Application Type: **Site Plan – Non-Residential**
Status: **First Referral**
Application Name: Trails at Crowfoot F9 AMD 1 Gas and Convenience Store
Case/AP#: **SP22-119**
Referral Received: October 27, 2022
Comments Due: November 29, 2022

Application Location: Southeast corner of Bayou Gulch Road and N. Pinery Pkwy
Review date: **November 10, 2022**
Plan reviewer: **Randall L. Capra, rcapra@parkeronline.org**
Phone: 303.805.3163

TOWN OF PARKER - FIRE/LIFE SAFETY:	R REVIEWED FOR CODE COMPLIANCE; REVISIONS REQUIRED
---	---

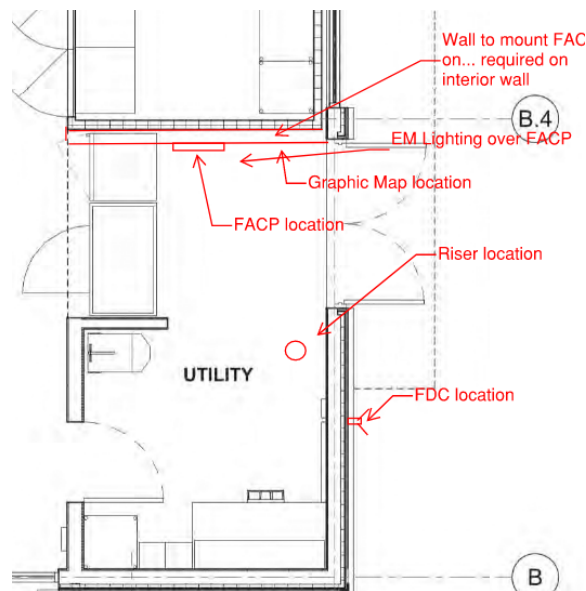
3. Per the requirements of [21 IFC Section 503.1.1 Buildings and Facilities] approved fire apparatus access roads shall be provided for every facility, building, portion of a building hereafter constructed or moved into or within the jurisdiction. The fire apparatus access road shall comply with the requirements of this section and shall extend to within 150 feet of all portions of the facility and all portions of the exterior walls of the first story of the building as measured by an approved route around the exterior of the building or facility (the building, as approximately 4,000 sf (or 40'x 100') cannot meet the requirement as measured from the center line of the fire apparatus as measured by an approved route from any point that a fire engine might park when responding to a call at this building).

Per the requirements of the code, the fire code official is allowed to increase the dimension of the 150 feet provided that the applicant meets Exception 1.1 of this section... “The building is equipped throughout with an approved automatic sprinkler suppression system installed in accordance with section 903.1.1, 903.1.2, or 903.3.1.3; a

sprinkler suppression system will be required. The building is to be sprinkled for pre-application meeting discussions. *Satisfied; applicant has acknowledged or addressed with second submittal.*

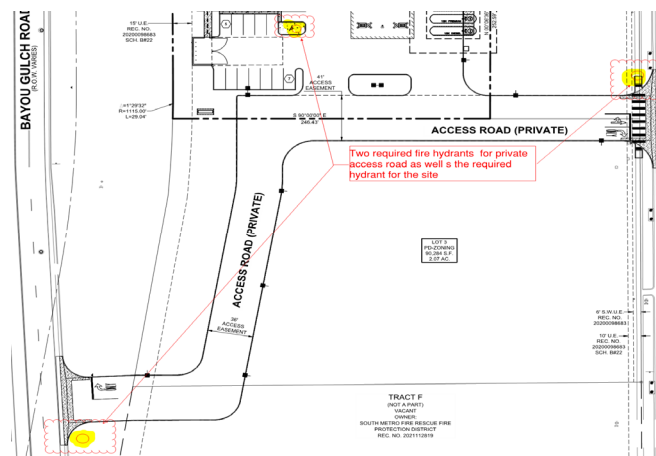
6. **Utility Plan Set:** The applicant shall provide a utility plan that identifies the locations of all utilities on the site (including natural gas and electricity). The overall utility plan shall identify the location of the required fire hydrant(s) and the required underground fire line UFL). The plan set shall identify the UFL on the plan (not just providing a note) while providing the length and diameter of the UFL (as measured from the T at the water main to the flange within the building). Address this issue on the plan set when resubmitting. ***In addition to the on-site hydrant required above, two additional fire hydrants will be required; a fire hydrant shall be located at the intersection of the private road access and Bayou Gulch Road as well as at the intersection of the private access road and Alpine Phlox Street.*** Address this issue on the plan set when resubmitting (see below for location of the two required hydrants for the private access road. *Not satisfied; while the applicant has not provided the required hydrant at the access road and Alpine Phlox Street. To note that an "existing hydrant near Alpine Phlox is to be utilized. Address this hydrant when resubmitting.*

Note – The UFL shall have its own tap; domestic water and the required fire hydrant shall have separate taps.

RESPONSE: HYDRANT HAS BEEN ADDED AT ALPINE PHLOX ACCESS PER COMMENT

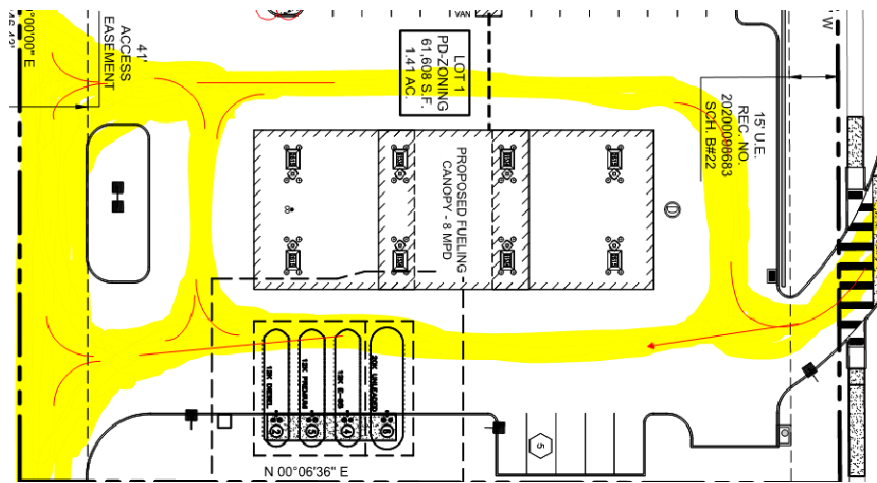
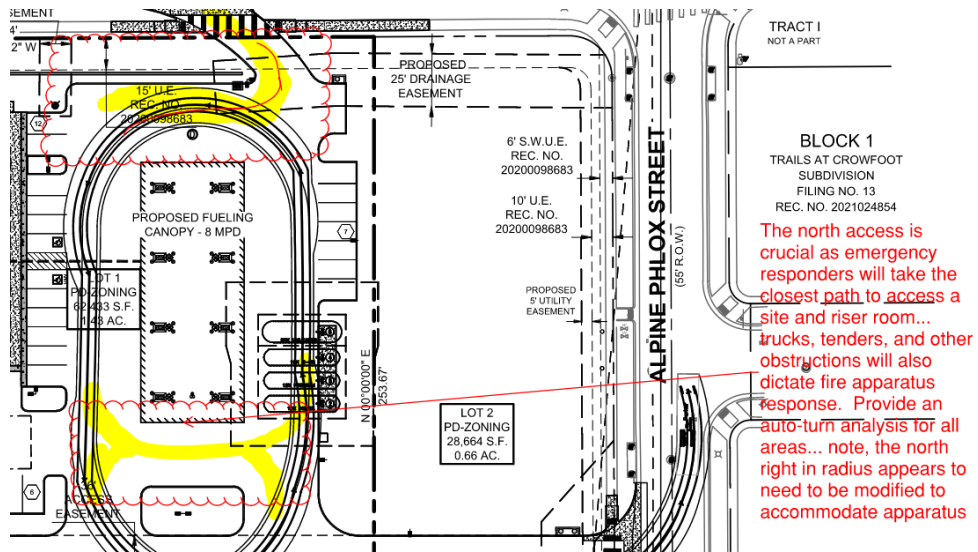
9. The applicant shall provide an auto turn analysis indicating that apparatus can navigate all portions of this site (both sides of the gas canopy); NO PARKING – FIRE LANE signage is required for any portion of the access where the 20-foot clear width requirement cannot be met. This is applicable for the loop around the canopy as well as for each entry. The access on each side of the canopy shall meet his requirement with no portion of the canopy encroaching into the required fire lane access road. See below for the areas required to be included in the auto turn analysis and address when resubmitting (failure to address all locations will result in a delay in approval for this project: *Not satisfied; in addition to what was provided, the applicant shall address what was required... see below... there are two area where the applicant has not provided the auto-turn analysis as required; see below and address when resubmitting:*

RESPONSE: AUTO-TURN ANALYSIS REVISED. DUE TO TOWN CODE FOR THE RIGHT-IN ACCESS IT IS NOT FEASIBLE TO MODIFY THIS ACCESS TO ALLOW FOR THE ESSENTIAL U-TURN ON THE NORTH OF THE CANOPY. ALL TRAFFIC MOVEMENTS HAVE BEEN PROVIDED TO SHOW FIRE TRUCK CAN SAFELY MANEUVER AROUND SITE IN ALL DIRECTION.
